Documents Requested
by NRC From Package
Produced by Tom Cooke,
Midland Plant Superintendent,
but not used as Deposition
Exhibits 10/22/80

MIDLAND PLANT PROJECT
MIDLAND, MICHIGAN

DOCUMENTATION AND MEETINGS RELATIVE TO SOILS

Question 25

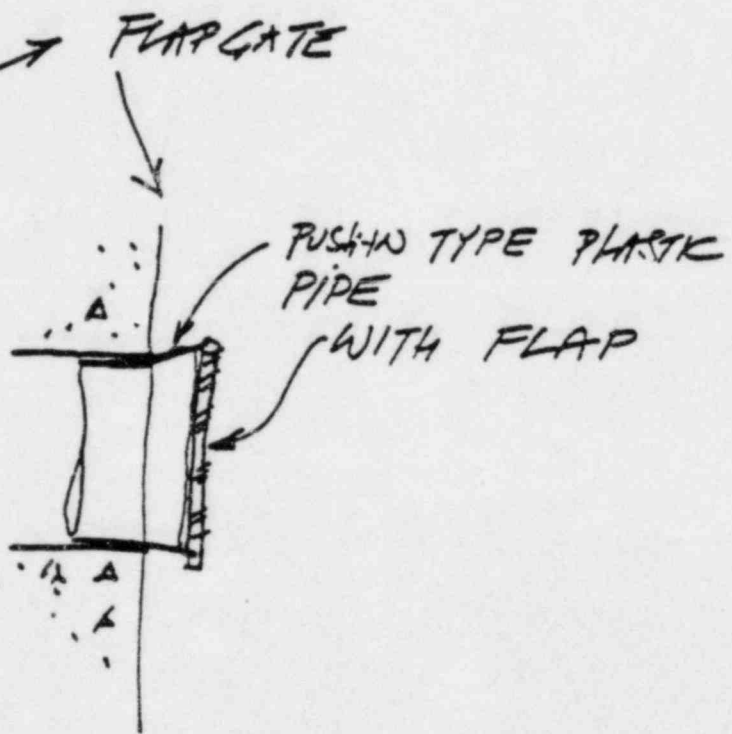
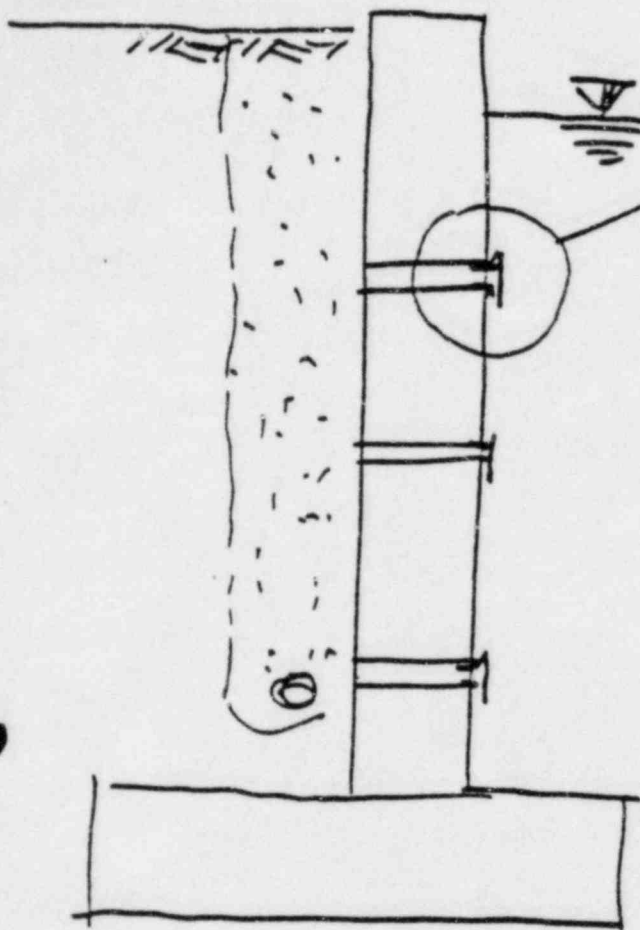
Johnson position is finite element analysis requested in Q25 is a ratchet beyond state of art when original damped mass analysis was done.

Apparently no resolution w/ Lipinski. Hood mentioned possibly continue discussion w/ conf call.

PLAN: FILL TEST LOCATIONS @ ADMIN BLDG.
FOUR TESTS DURING ORIGINAL FILL.
1" = 20'

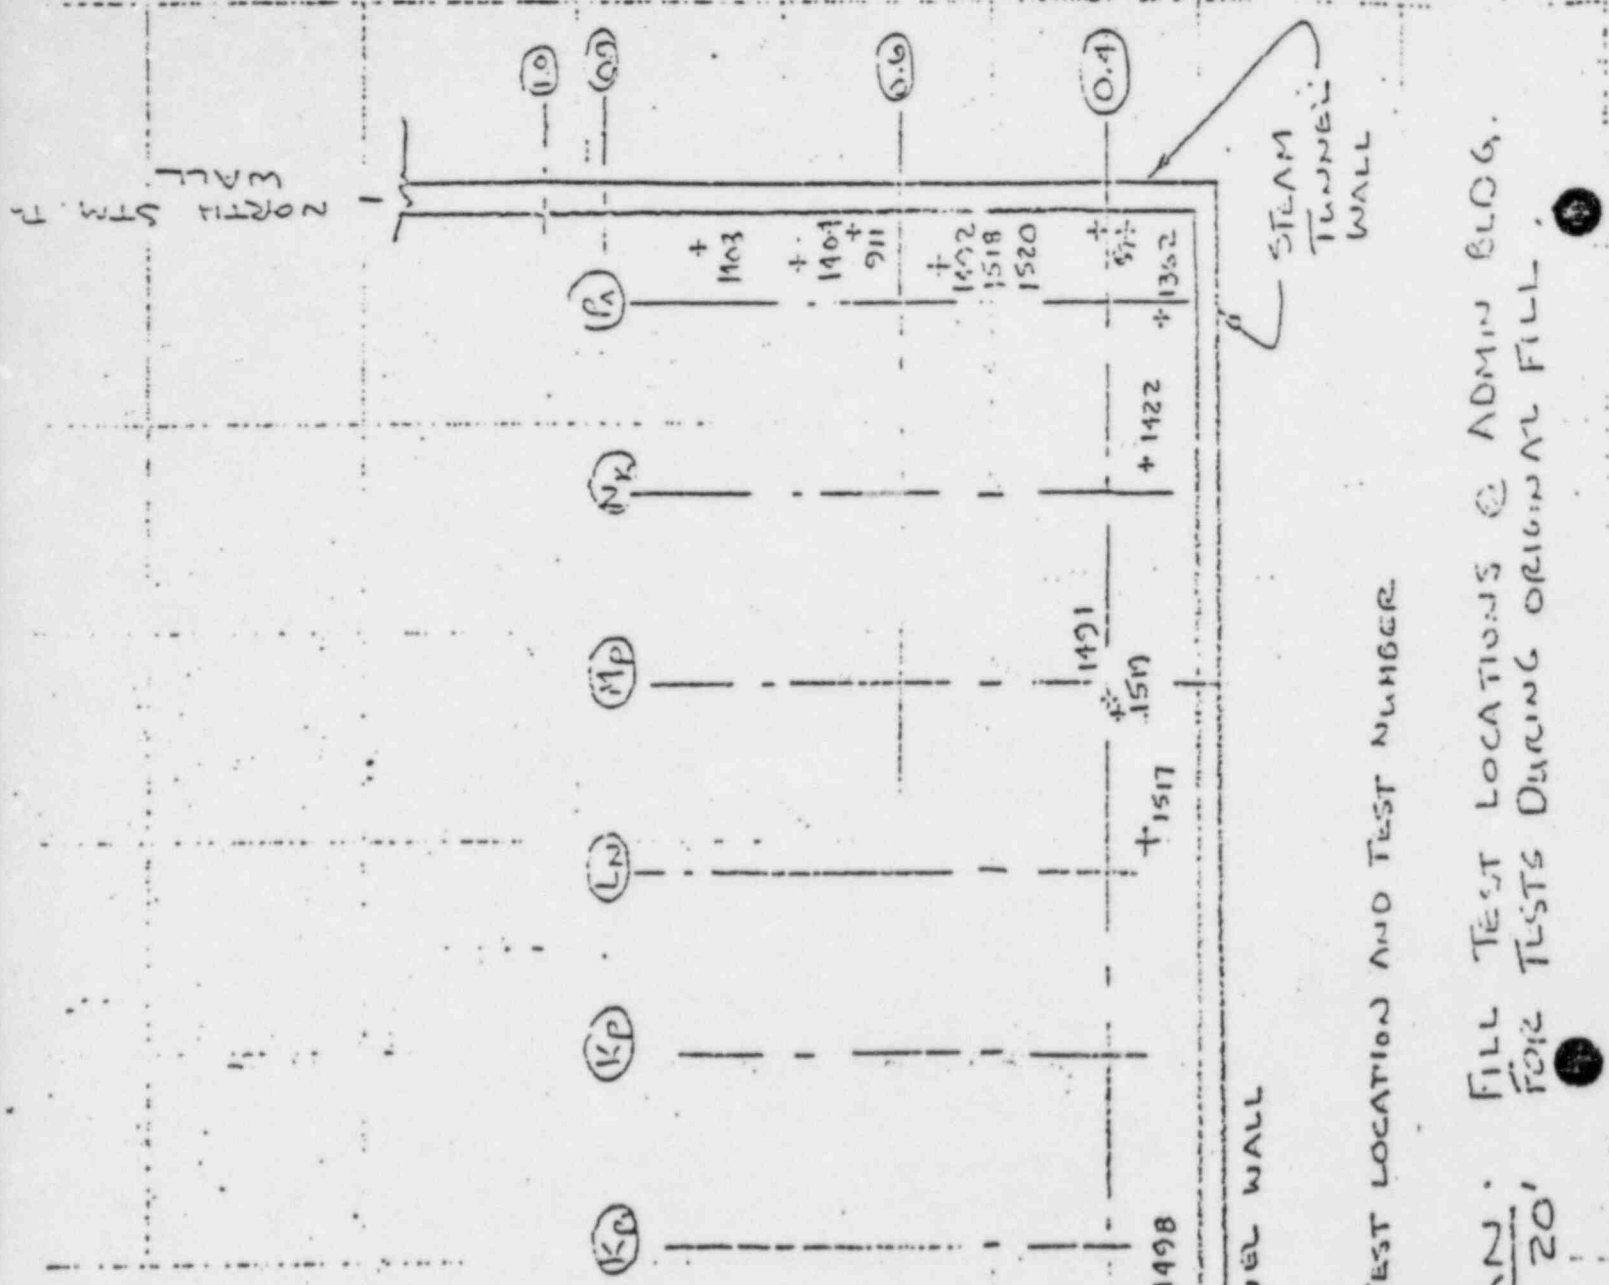
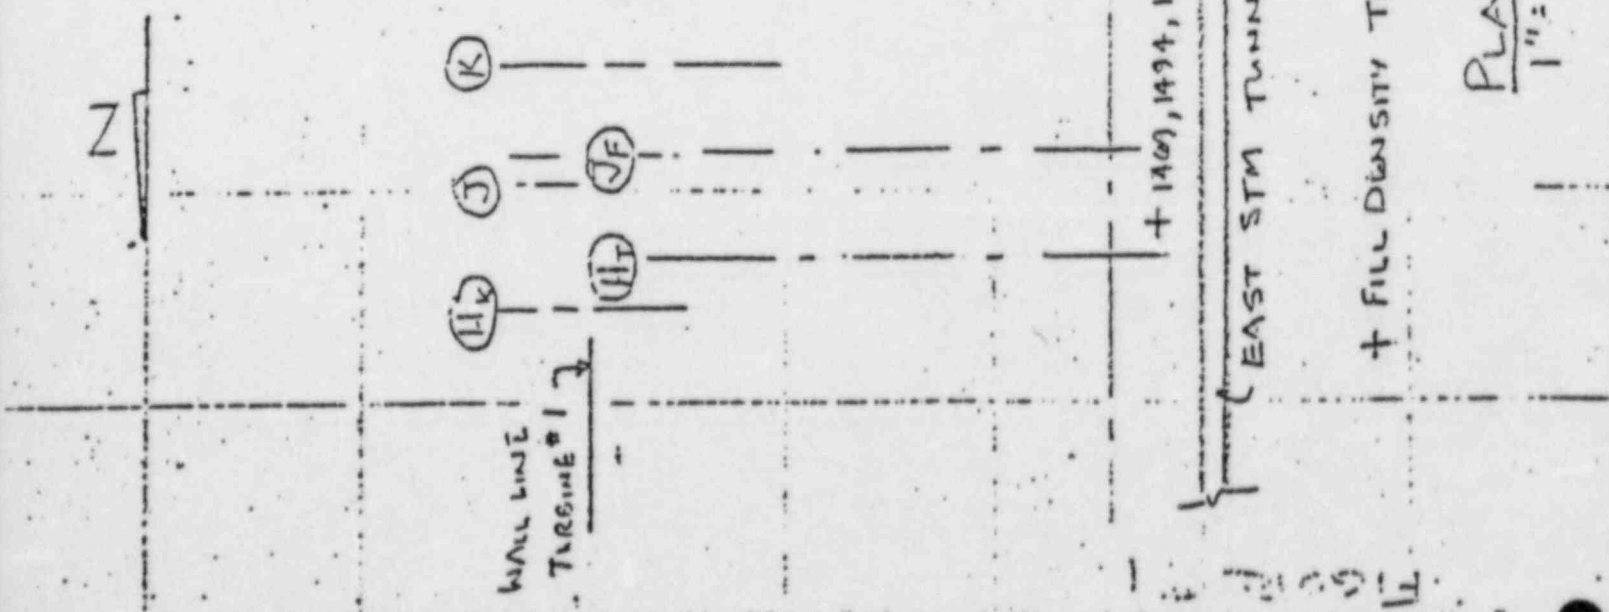
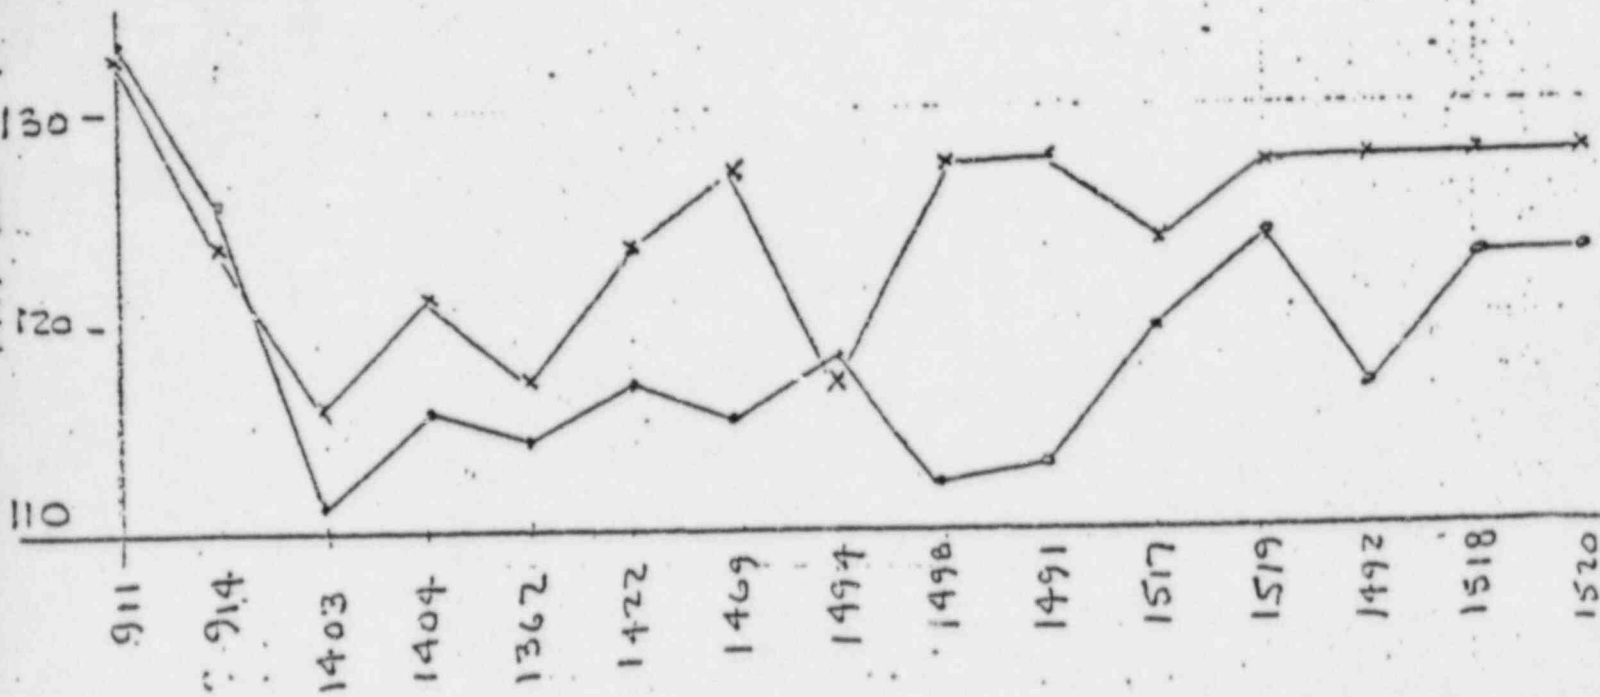
1. A summary of fifteen (15) compacted fill density tests taken by U. S. Testing to evaluate the subject fill as it was compacted is provided in Table #1. The location of each test is plotted in Figure #1. Although several initial tests indicate test failure due to insufficient compaction, each failure is properly cleared by a passing test at or near the location of the failure.

3. The value of maximum laboratory dry density selected for comparison of the in-place dry densities in the subject fill varies between 132.9 lb./ft.³ and 116.0 lb./ft.³. This variation includes most of the full range of maximum laboratory density standards which represent significantly differing soil characteristics of the clay soils in use on this project. A graph of the maximum laboratory dry density plotted with the corresponding in-place dry density for each test is given in Figure #2. Note that for three compacted fill density tests (1469, 1494 and 1493) taken within a few feet of each other and at the same elevation, two significantly different maximum laboratory densities were used as the compaction standard by the same U. S. Testing technician.

PLAN: FILL TEST LOCATIONS @ ADMIN BLDG.
 FOR TESTS DURING ORIGINAL FILL
 1" = 20'

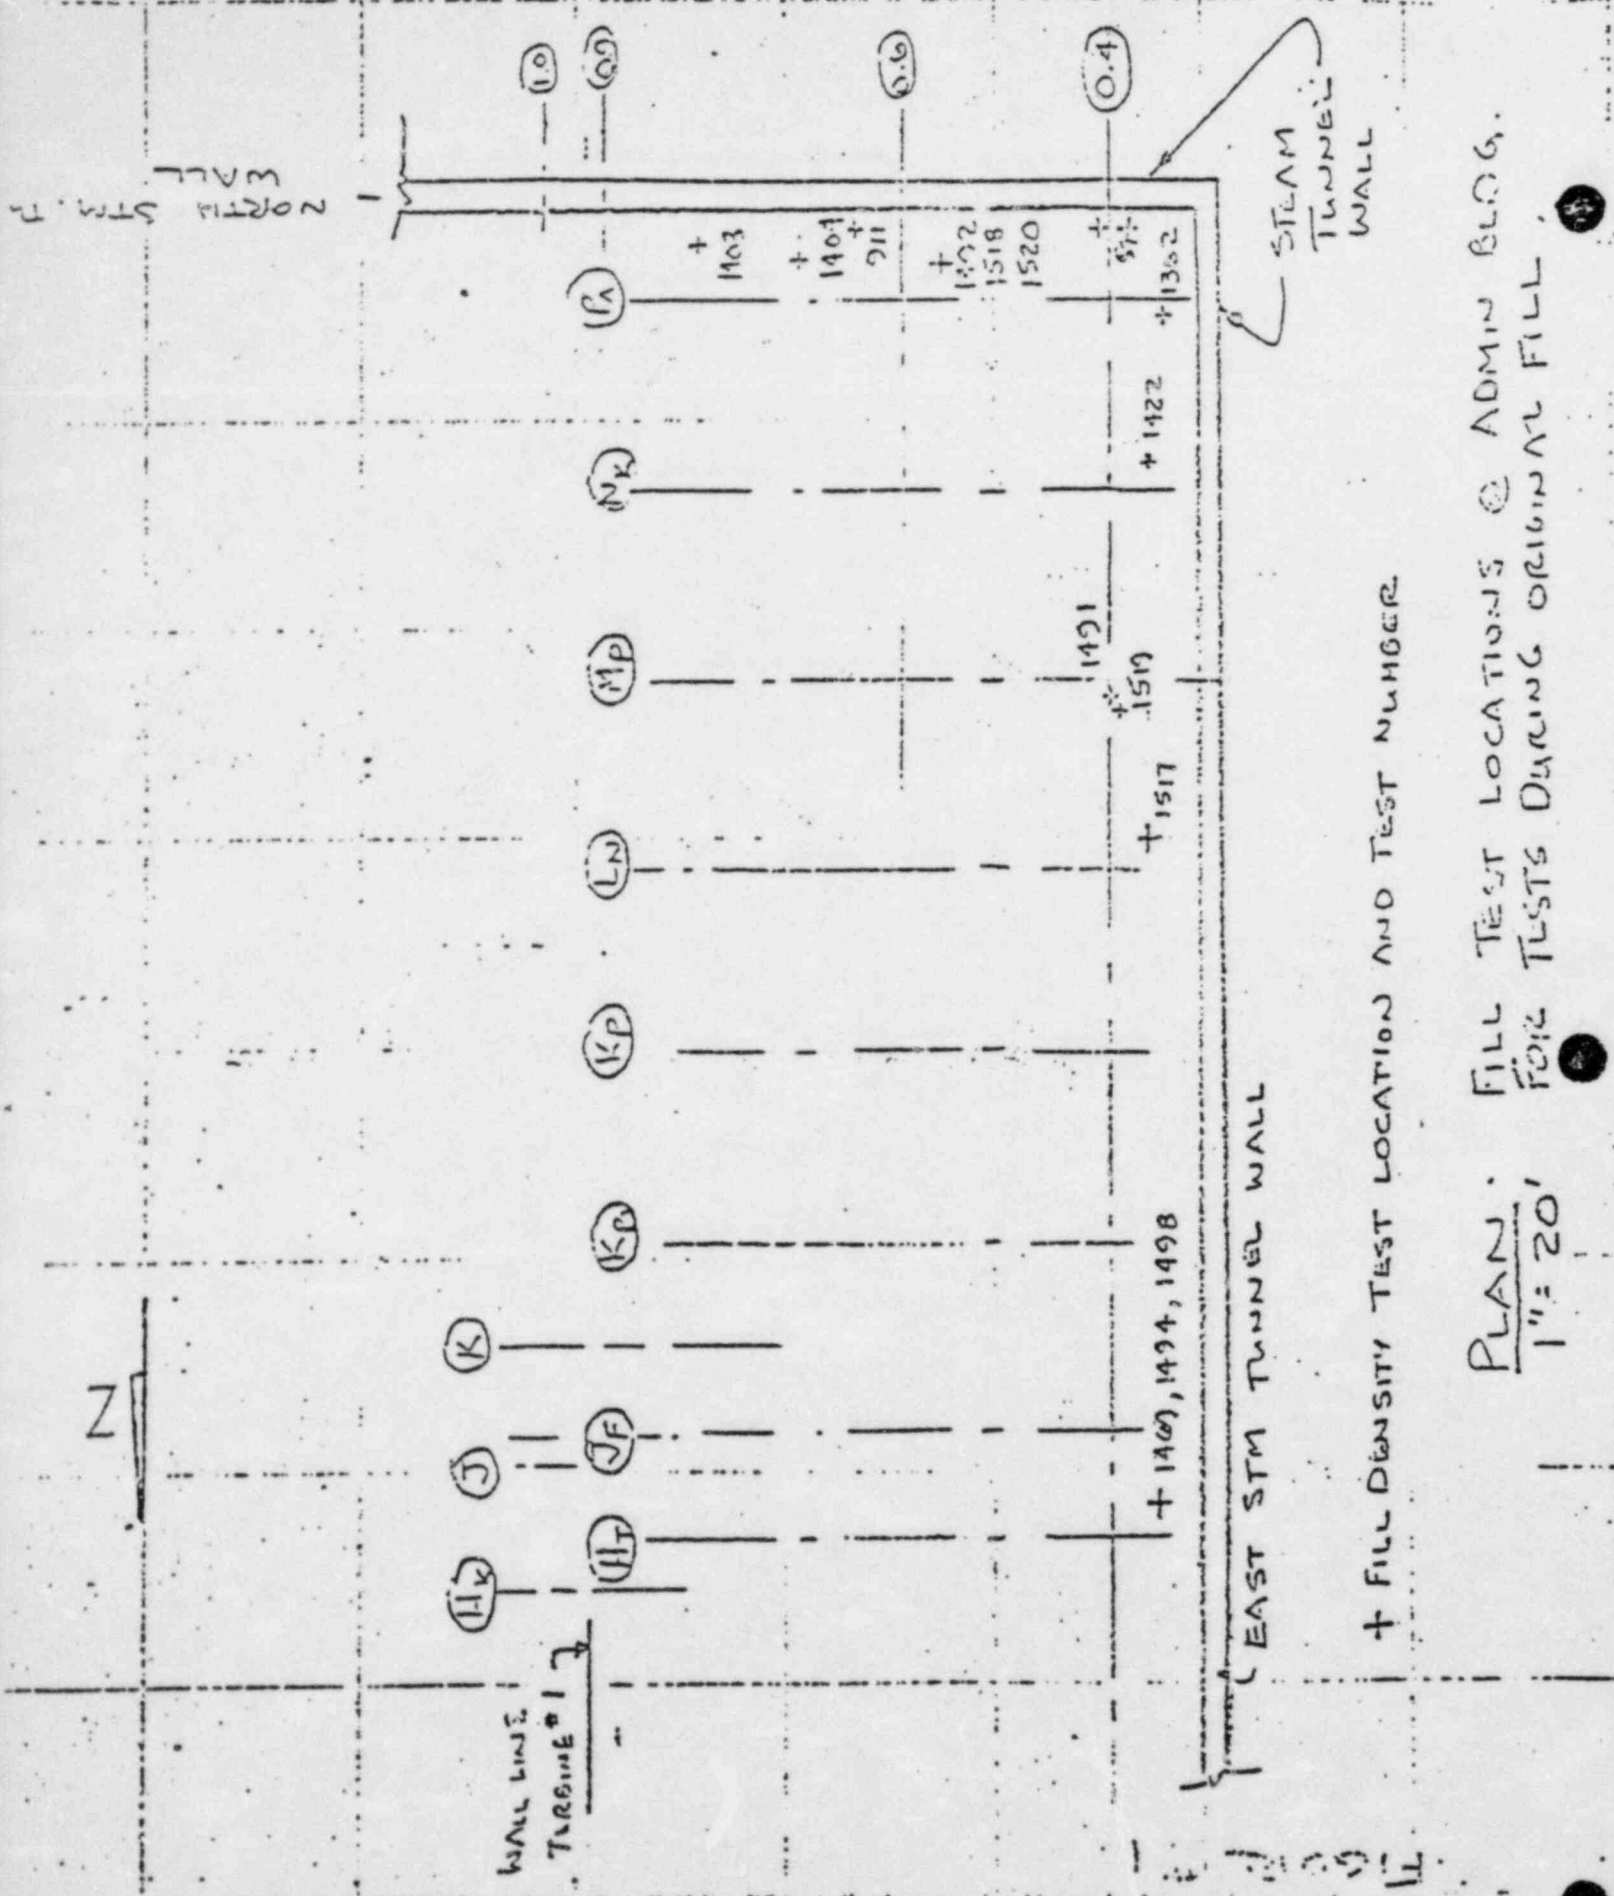
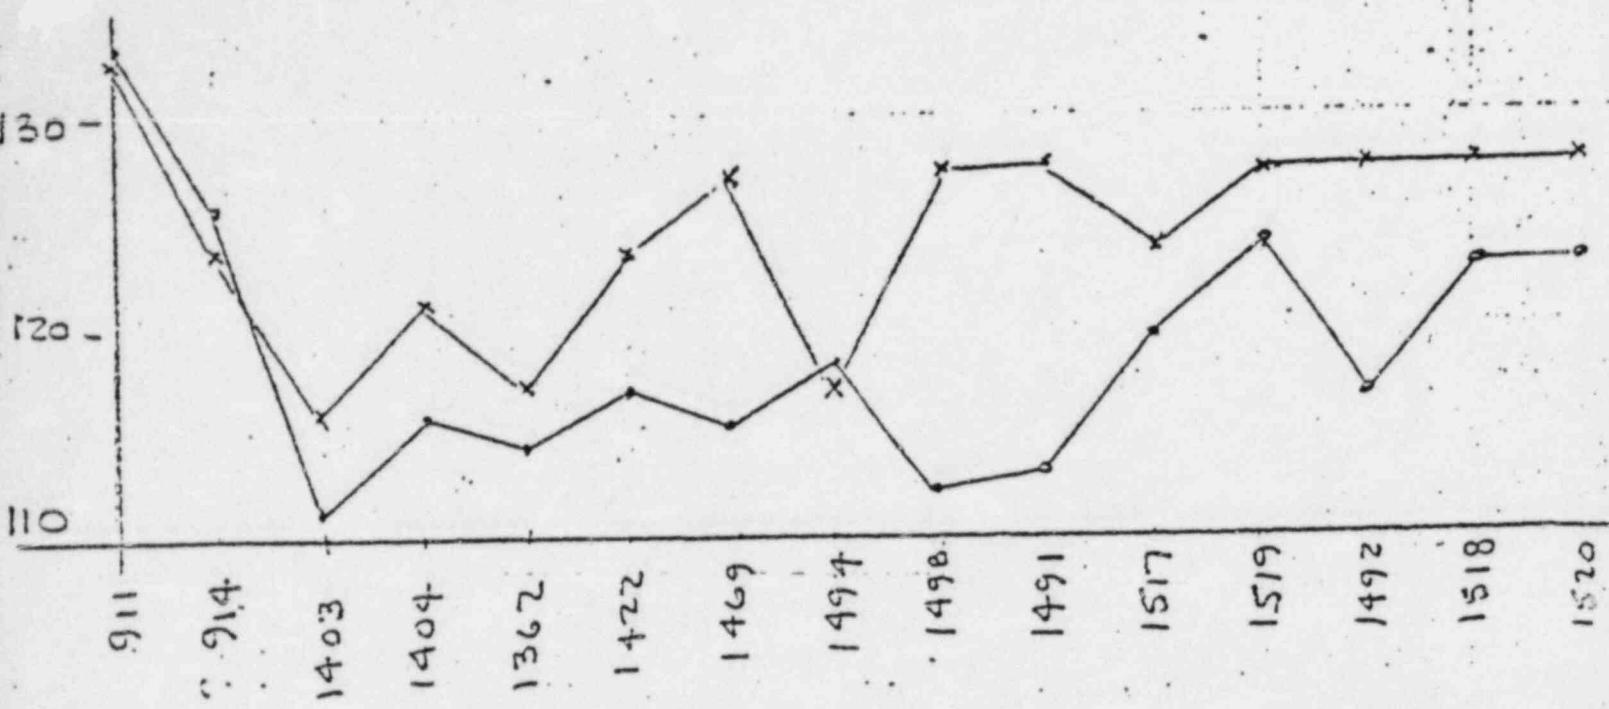
1. A summary of fifteen (15) compacted fill density tests taken by U. S. Testing to evaluate the subject fill as it was compacted is provided in Table #1. The location of each test is plotted in Figure #1. Although several initial tests indicate test failure due to insufficient compaction, each failure is properly cleared by a passing test at or near the location of the failure.

3. The value of maximum laboratory dry density selected for comparison of the in-place dry densities in the subject fill varies between 132.9 lb./ft.³ and 116.0 lb./ft.³. This variation includes most of the full range of maximum laboratory density standards which represent significantly differing soil characteristics of the clay soils in use on this project. A graph of the maximum laboratory dry density plotted with the corresponding in-place dry density for each test is given in Figure #2. Note that for three compacted fill density tests (1469, 1494 and 1498) taken within a few feet of each other and at the same elevation, two significantly different maximum laboratory densities were used as the compaction standard by the same U. S. Testing technician.
